COMFORTFIT
BY VILLA INTERNATIONAL
13760 MIDWAY STREET
CERRITOS CA 90703
(562) 404-8111
FAX (562) 404-7781

TITLE: 2023 DSDP
87" HOME THEATER

DWG. NO. CF7000538 | REV. H

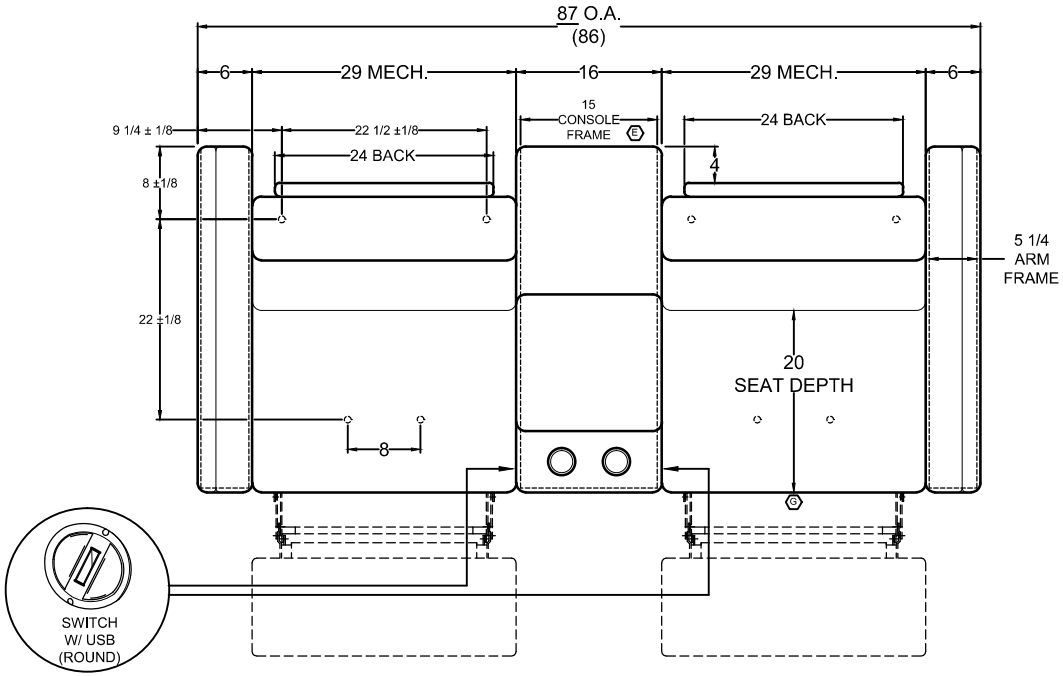
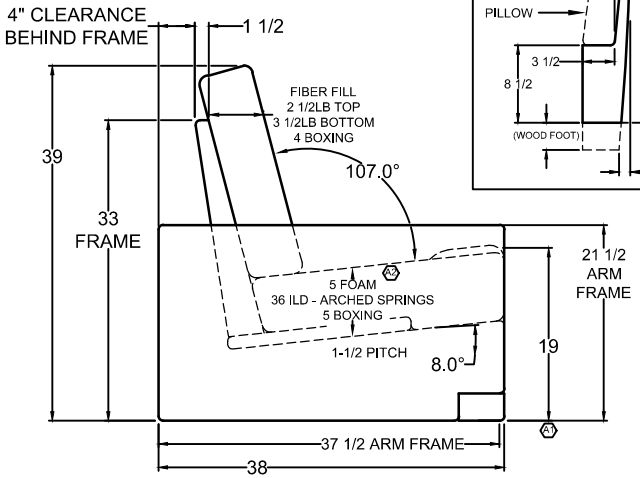
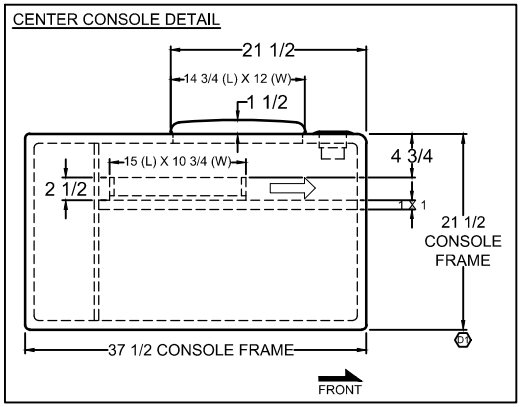
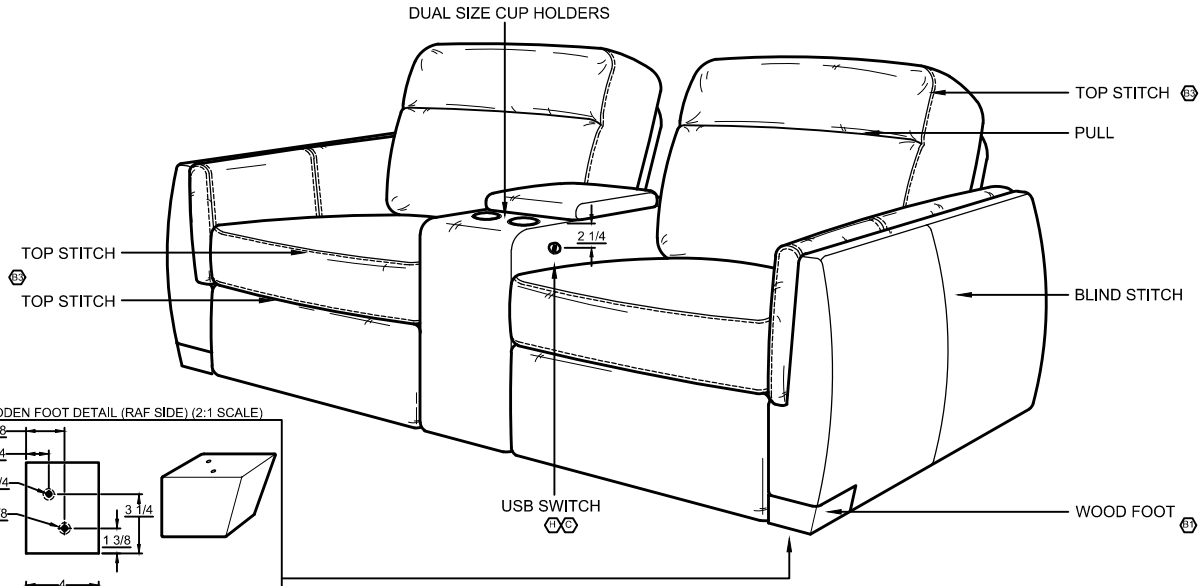
JA	H	CHANGE SWITCH HEIGHT FROM TOP OF CONSOLE TO 2-1/4"; WAS 3-1/4". (REF. ECO #004-2022)	02.11.22
JA	G	PER KB, ADD 20" SEAT DEPTH DIMENSION TO DRAWING.	07.14.21
JA	F	PER RL, ADD WOODEN FOOT DETAIL AND DIMENSIONS.	07.14.21
JA	E	PER RL, CHANGE CONSOLE FRAME WIDTH TO 15"; WAS 15-1/4".	06.01.21
JA	D	PER RL, [1] CHANGE CONSOLE FRAME HEIGHT TO 21-1/2"; WAS 23-1/2". [2] UPDATE DIMENIONS IN ARM FRAME DETAIL.	05.26.21
JA	C	PER RL, MOVE FOOTREST SWITCH TO THE CENTER CONSOLE.	05.24.21
JA	B	PER RL, [1] CHANGE ARM STYLE AND ADD WOODEN FOOT. [2] ADD FRONT OF ARM FRAME DETAIL. [3] CHANGE WELTS TO TOP STITCH.	05.19.21
JA	A	[1] CHANGE SEAT HEIGHT TO 19"; WAS 18-1/2". [2] CHANGE SEAT FOAM TO 5"; WAS 3". (REF. ECO# 003-2021)	03.17.21
